Updated comment and remedy for comment #214

33.6 Data Link Layer classification need to be updated in order to:

Proposed Remedy:

Figure 33–49—PSE power control state diagram

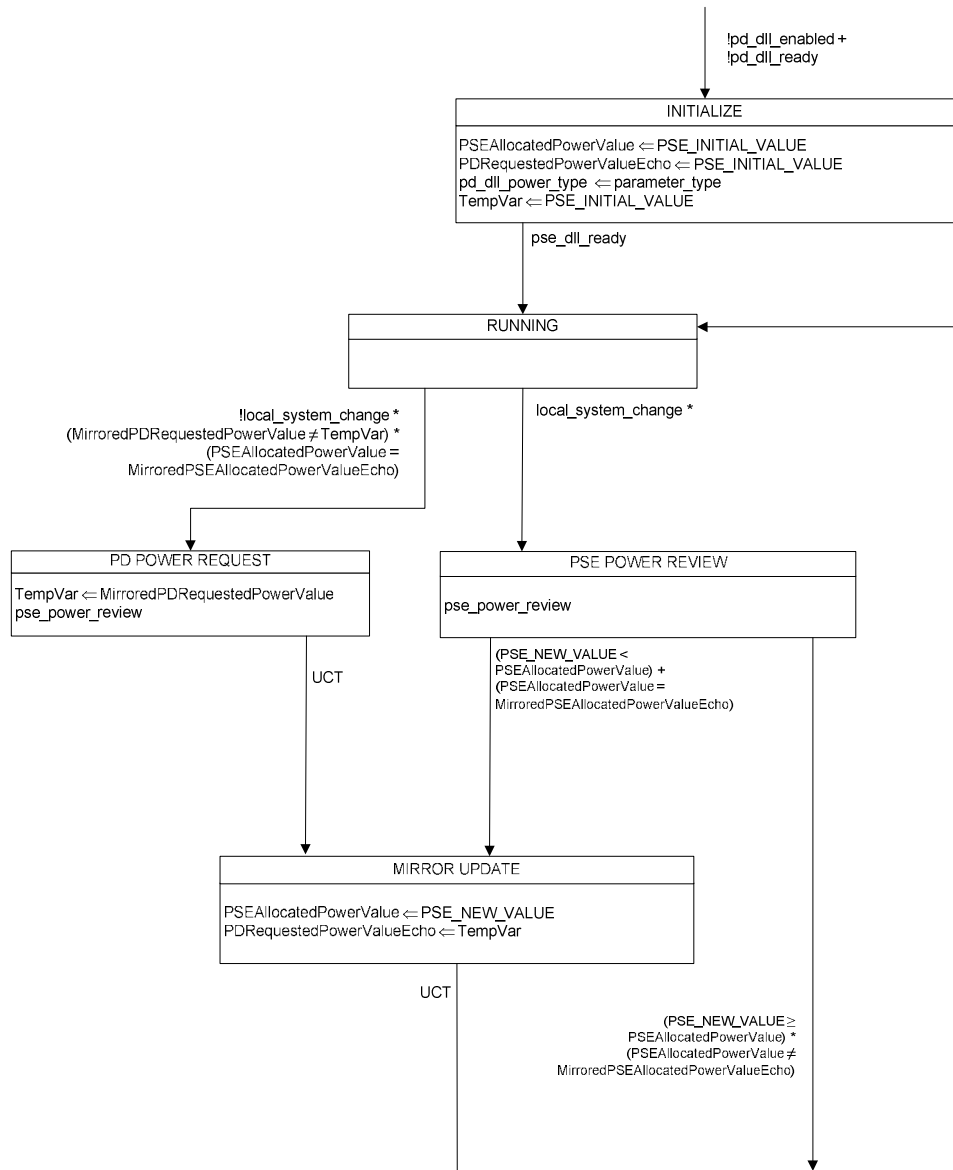
1. Cleanup parameters that are not used by single-signature DLL state machines.
2. Support dual-signature PD with the following objectives:
 - 2.1 Power Demotion use cases.
 - 2.2 Addressing cases when power is not sufficient for one of the modes or both modes.
2. To fix some error regarding the sync between variable names in PD state machine and its variable list, clause 33.6 PD/PSE DLL power state machine (Figures 33-49 and 33-50) and its variable list.

The power control state diagrams shown in Figure 33-49 and Figure 33-50 are used for PSEs connected to single-signature PDs and dual-signature PDs.

For dual-signature PDs, the state machine is used for mode A and mode B independently.

A control variable output by the PD or PSE control state diagrams (Figure 33-49 and Figure 33-50).

The power control state diagrams for PSEs and PDs specify the externally observable behavior of a PSE and PD Data Link Layer classification respectively. PSE Data Link Layer classification shall provide the behavior of the state diagram as shown in Figure 33–49. PD Data Link Layer classification shall provide the behavior of the state diagram as shown in Figure 33–50.

Figure 33–50—PD power control state diagram

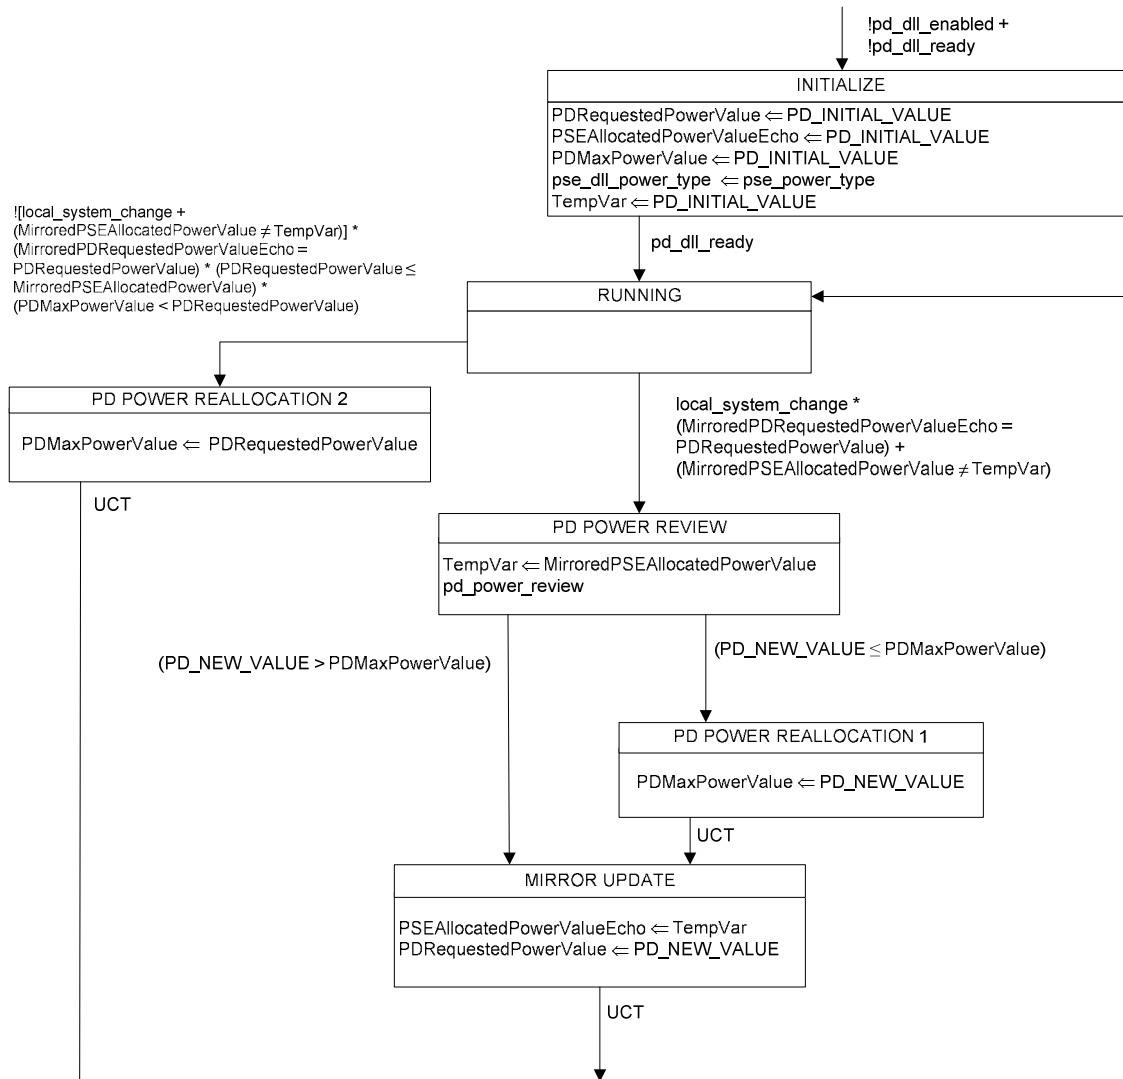
pse_dll_power_level is not used by Figure 33-50 therefore deleted from 33.6.3.3.

pse_dll_power_type is used in Figure 33-50 and missing from 33.6.3.3.

A control variable output by the PD control state diagram (Figure 33-50) that based on the information in Table 79-6b **bit #1**, in order to ensure execution of PSE new power allocation correctly per pairset. This variable is not used in single-signature PD.

A control variable output by the PD power control state diagram (Figure 33-50) that indicates the PSE type as 1 or 2, see 79.3.2.4.1.
